RE: Subdivision and Rezoning & Secondary Plan Amendment – Gunn Redonda [File No. DASZ 18/2014]

<u>Secondary Plan Amendment</u>

Subdivision and Rezoning

Land Use Concept

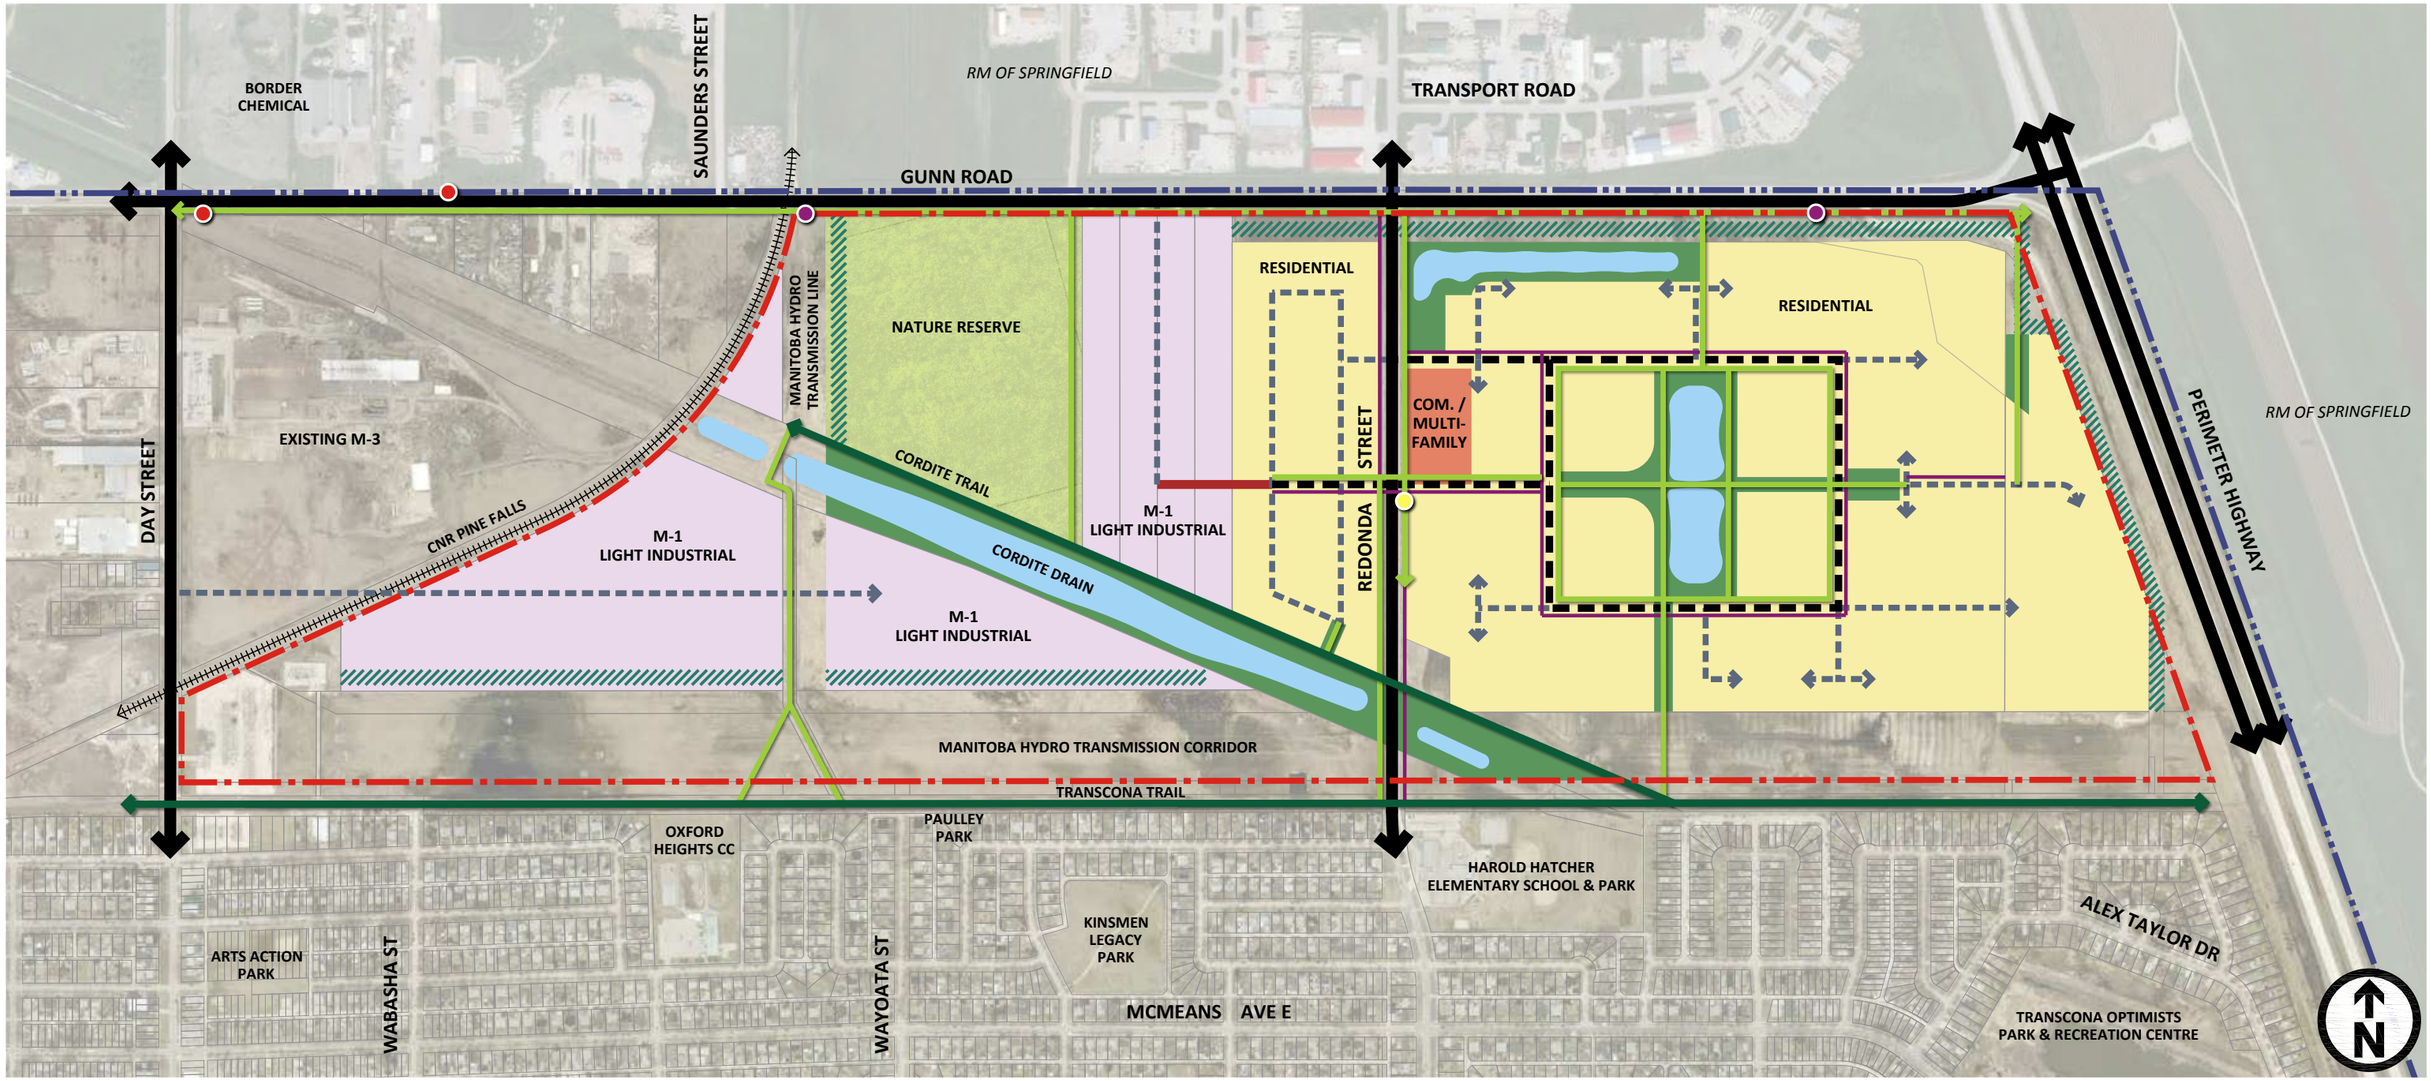
The land uses identified in the Transcona North Precinct Plan for the Northwoods Development include low density residential, commercial/multi-family, and park. The proposed plan maintains the same land uses as shown on the Land Use Concept Map except the layout has been redesigned which resulted in some very minor discrepancies on the figures. Accordingly, the redesign requires amendments to the following figures in the Precinct Plan:

- Figures 3, 4, 7, and 8 will be consolidated into one Figure, Figure 3.
- Figures 6a and 6b will be removed.

Municipal Trunk Services

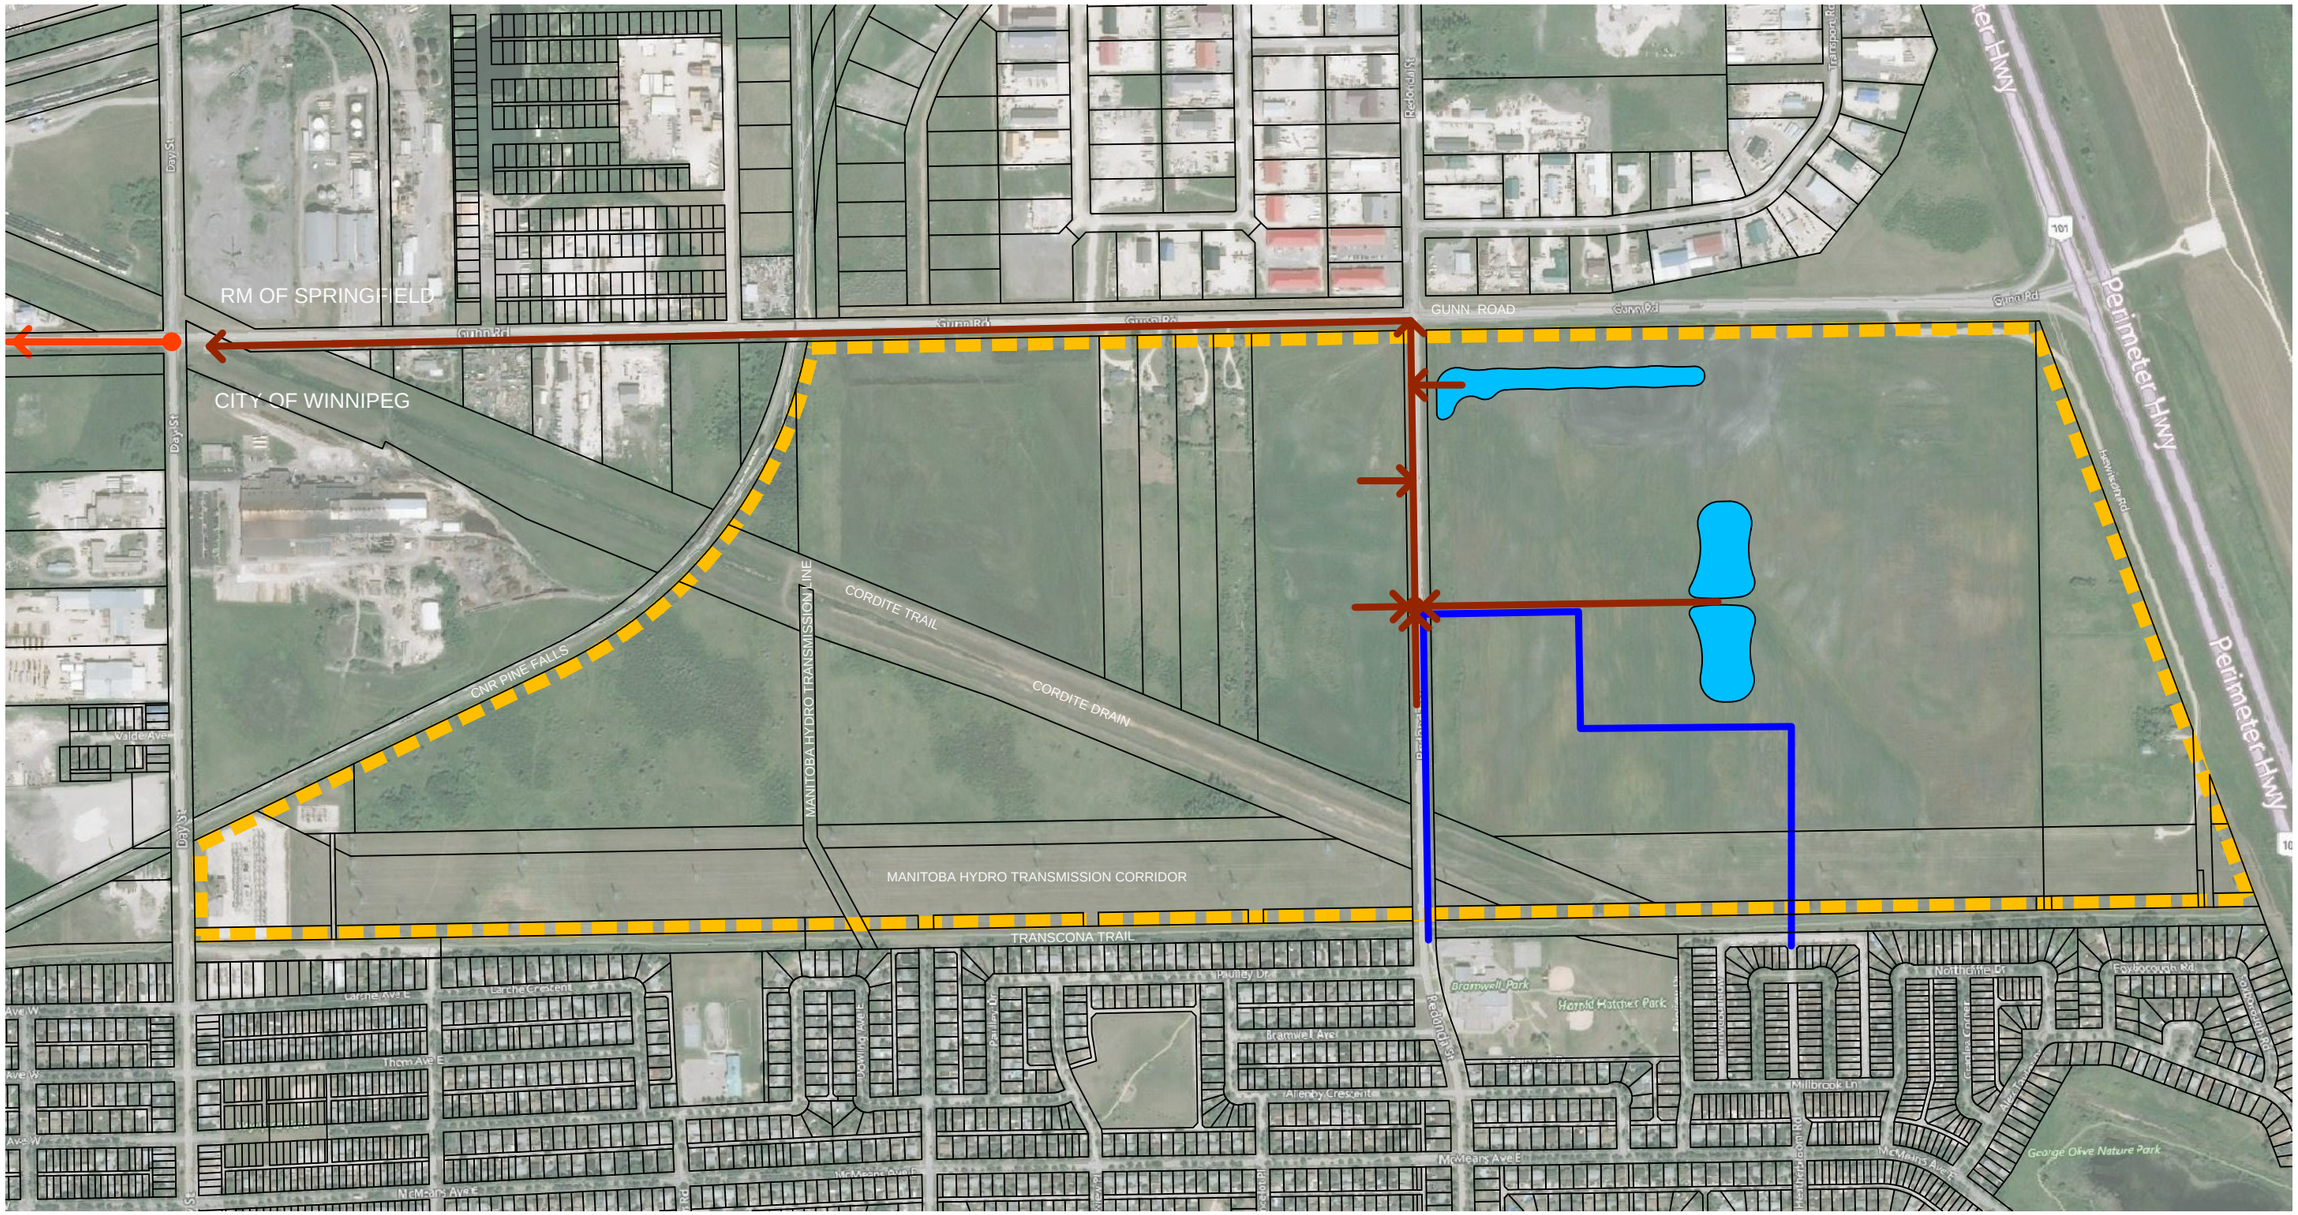
- Figure 9 will be revised to align with the proposed redesign.
